STAFF REPORT

TO: Planning Commission
FROM: Ben Hetzel, Lake Elmo City Planner
AGENDA ITEM: **8265 Hidden Bay Trail N Variance**
REVIEWED BY: Ben Hetzel, City Planner

The Planning Commission is being asked to hold a public hearing, review, and make a recommendation on the request to install a sewage treatment system within 75 feet of a wetland.

CERTIFICATE OF SURVEY

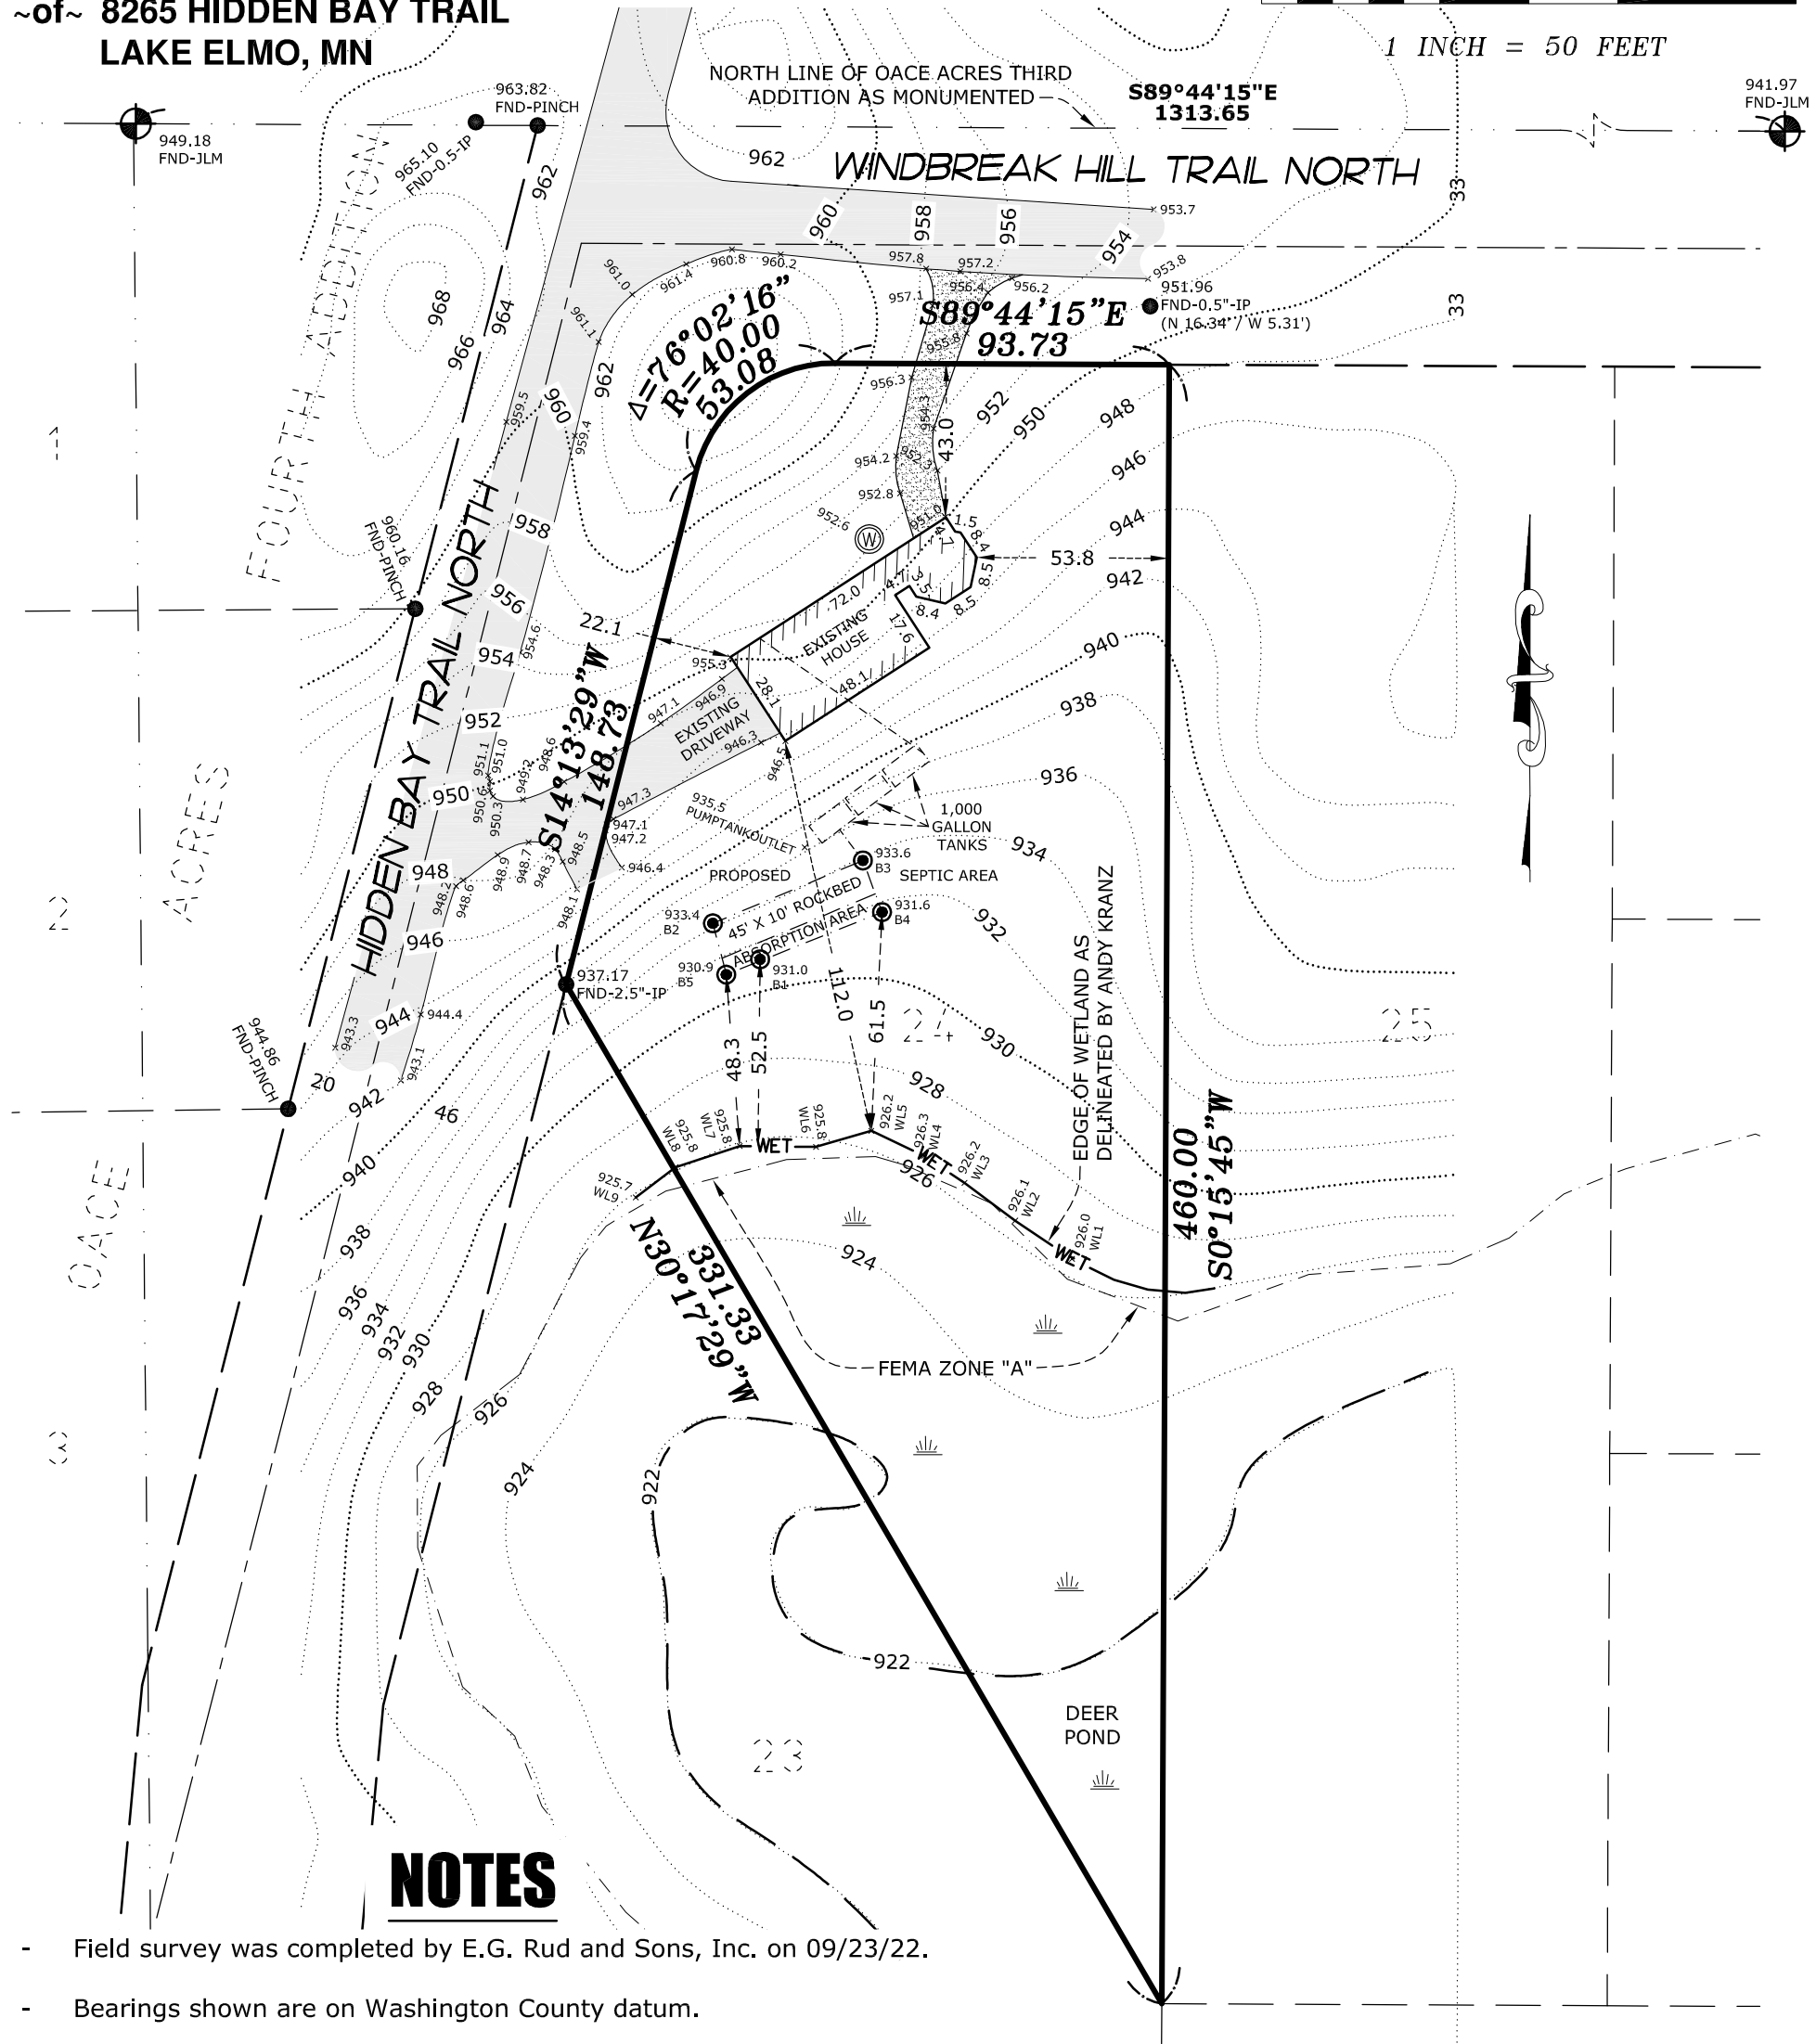
The system must be at least 10 feet from the nearest property line.

Ben,
The proposed septic system must be installed a minimum of 10 feet from the property lines. This setback requirement should be shown on the site plan. Engineering has no other comments.

5. This variance approval is for a reduced wetland setback in the proposed component locations as per the revised site survey dated October 18, 2022. Any deviation in system component locations would require approval from the City of Lake Elmo.

Wetland Delineation Map 8265 Hidden Bay Trail N Washington County, MN

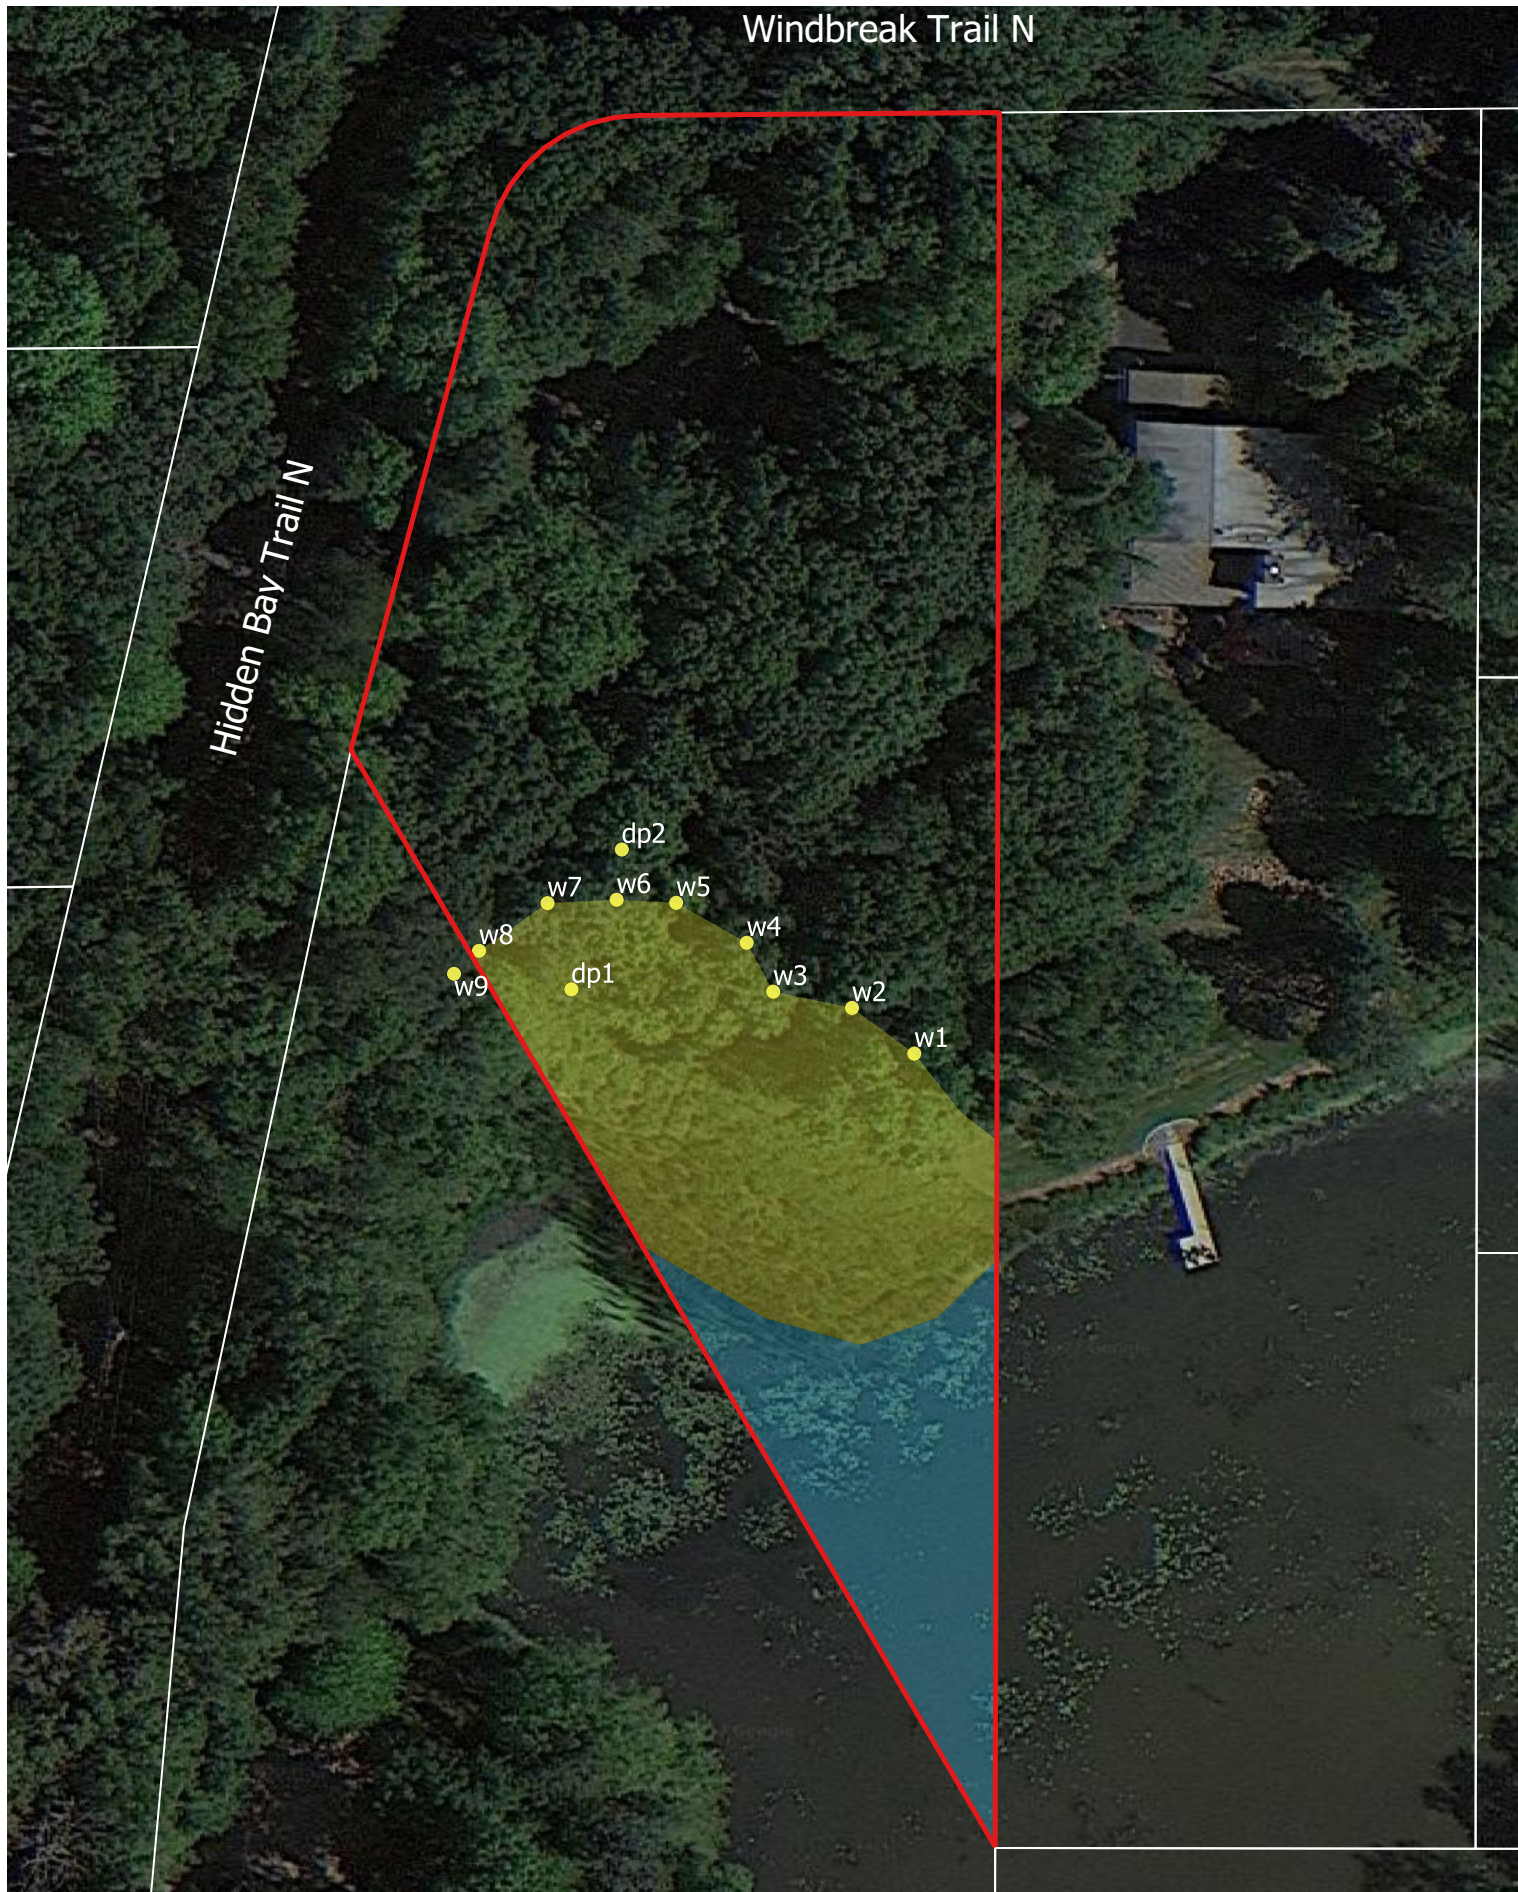
w4 to pump tank outlet:	82.5 ft
w4 to B4:	69.5 ft
w5 to B4:	62.0 ft
w6 to B1:	52.0 ft
w7 to B5:	49 ft
